Access Compliance Report

Public Rights-of-Way

(Curb Ramps)

Intersection ID: 32120	Main Street: ALLENWOOD_RD	Cross Street: DUNDALK_RD	Location: W
ADA ID: FD546927B33C	Ramp Type: Perp	Initial Pass/Fail: Fail	Overall Compliance: No
Severity Score: 8.75			
Codes/Mitigation Info/Possible Solution		Field Measurements/Component Compliance

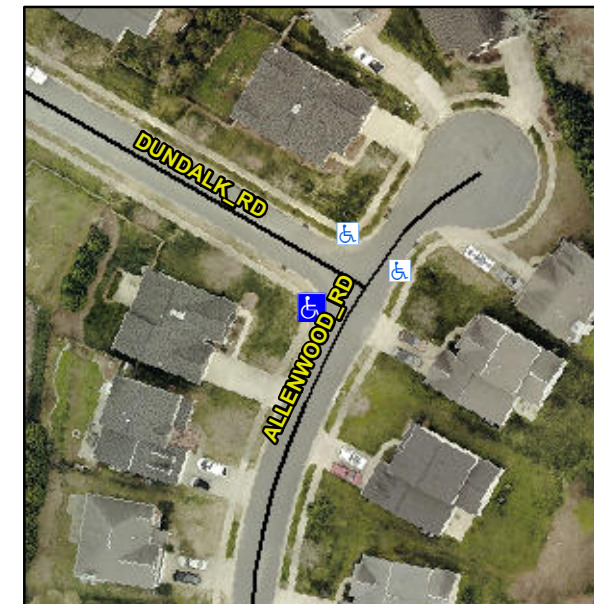
Not Found, R304.5.1

Compliance	Description	Data	Compliance	Description	Data
N/A	Ramp Length (in)	48.0	Yes	Ramp Slope (%)	6.1
No	Ramp Width (in)	42.0	Yes	Ramp XSlope (%)	0.8
N/A	Flare Type LT	N/A	N/A	Flare Type RT	N/A
N/A	Flare Slope LT (%)	N/A	N/A	Flare Slope RT (%)	N/A
N/A	Flare Traversable LT?	N/A	N/A	Flare Traversable RT?	N/A
N/A	Landing Length (in)	N/A	N/A	DWS Provided?	N/A
N/A	Landing Width (in)	N/A	N/A	DWS Contrast?	N/A
N/A	Landing Slope (%)	N/A	N/A	DWS Length (in)	N/A
N/A	Landing X Slope (%)	N/A	N/A	DWS Full Width?	N/A
N/A	Landing Curb? (Y/N)	N/A	N/A	DWS Offset (in)	N/A
N/A	Shared Landing?	N/A			
N/A	Gutter Ponding?	N/A	N/A	Gutter Slope (%)	N/A
N/A	Gutter Lip Ht (in)	N/A	N/A	Gutter X Slope (%)	N/A
N/A	Painted X Walk1?	No	N/A	Painted X Walk2?	N/A
	X Walk 1 Direction	To SE		X Walk 2 Direction	N/A
N/A	X Walk 1 Width (in)	N/A	N/A	X Walk 2 Width (in)	N/A
	X Walk 1 Slope (%)	2.3		X Walk 2 Slope (%)	N/A
	X Walk 1 X Slope (%)	0.1		X Walk 2 X Slope (%)	N/A

Remove & Replace Entire Ramp.
